Municipal Planning Commission AGENDA

Monday, March 4, 2024 — 6:30 p.m. Bartlett City Hall Assembly Chamber

PLANNING COMMISSION

Staff Comments

1. SETBACKS

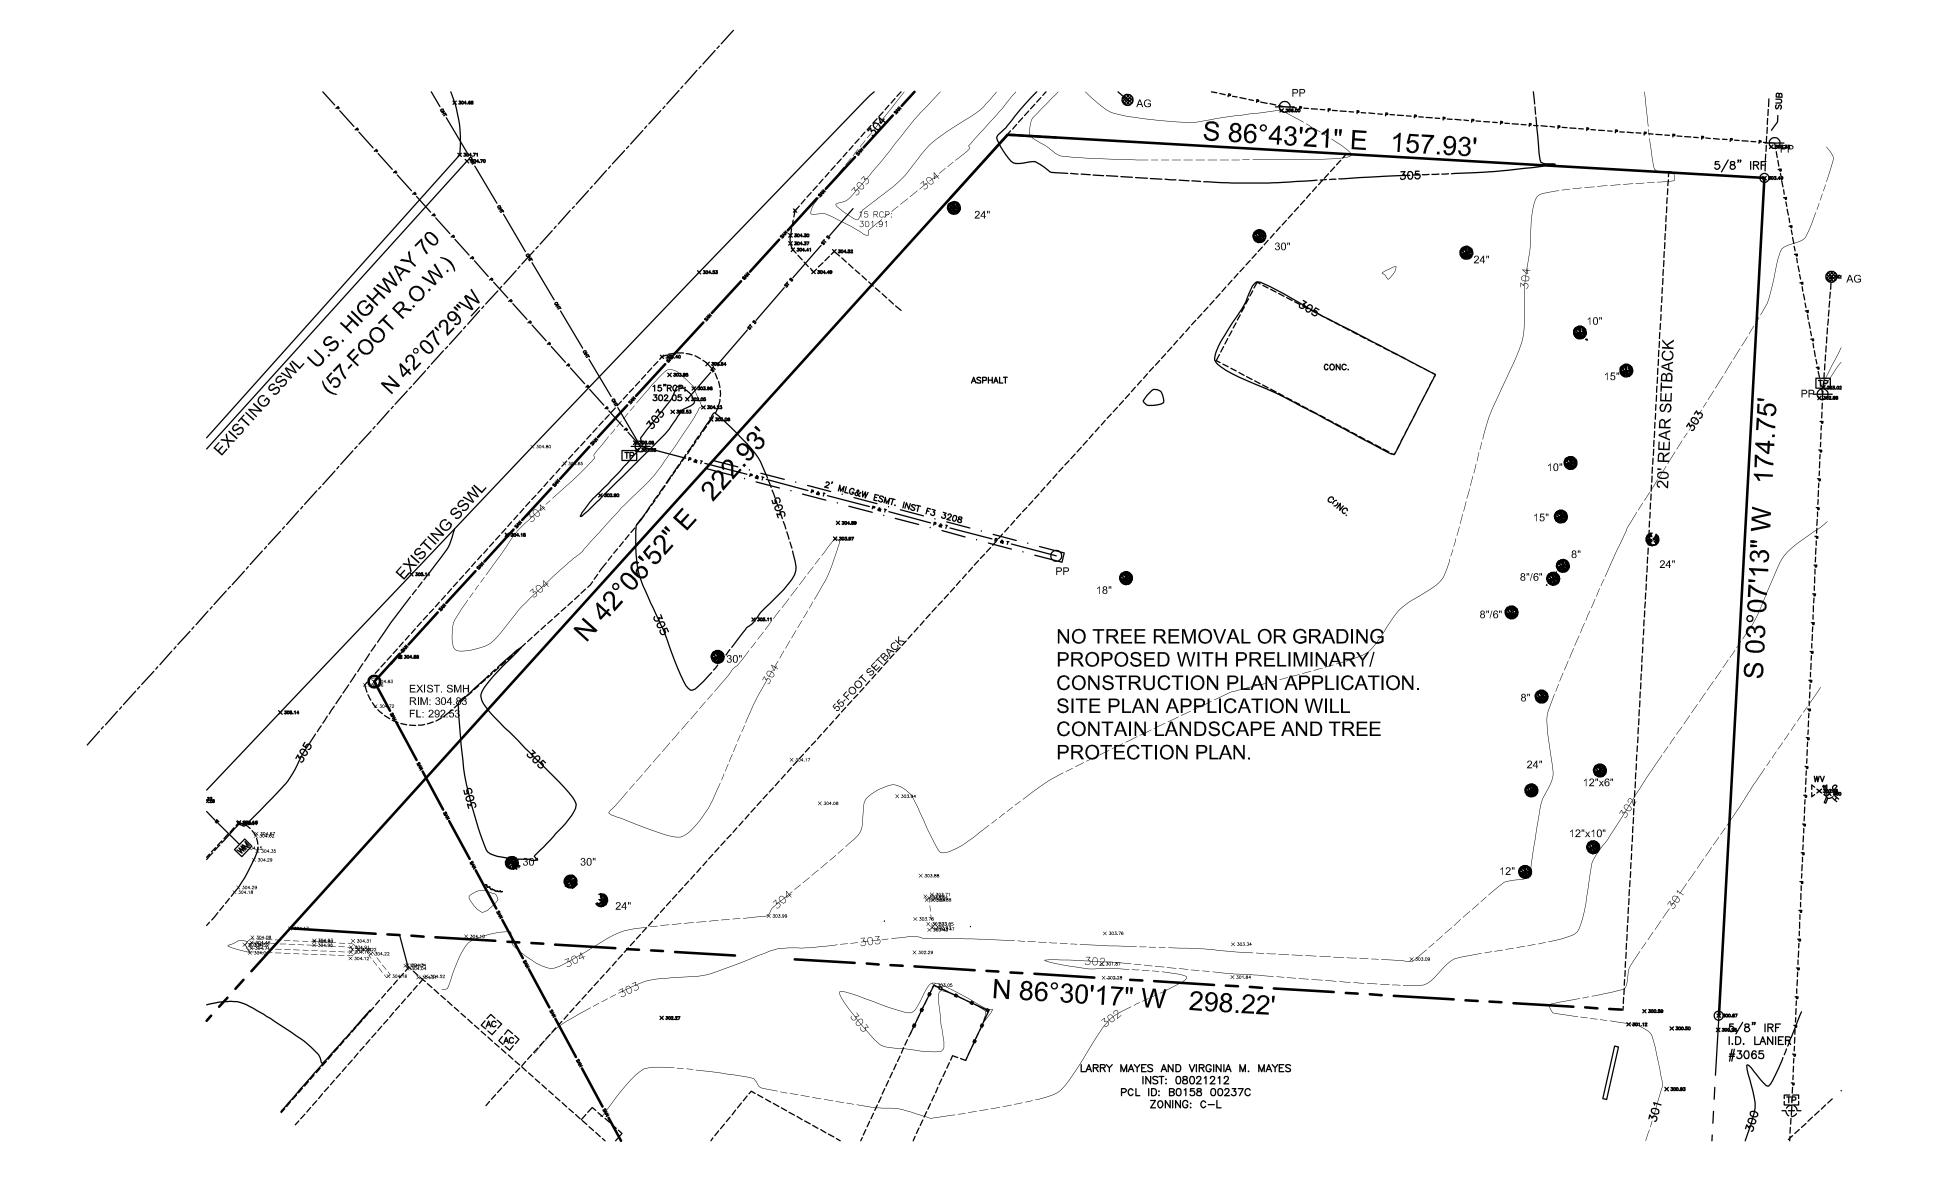
- 1. The applicant shall revise the plat to reflect the 45 foot front yard setback instead of the 55 foot front yard setback shown on the proposed plat.
- 2. The applicant must designate Lot 1 and Lot 2 on the proposed plat to be recorded.
- 3. The applicant must obtain Final Plan and Site Plan approval from the Planning Commission.
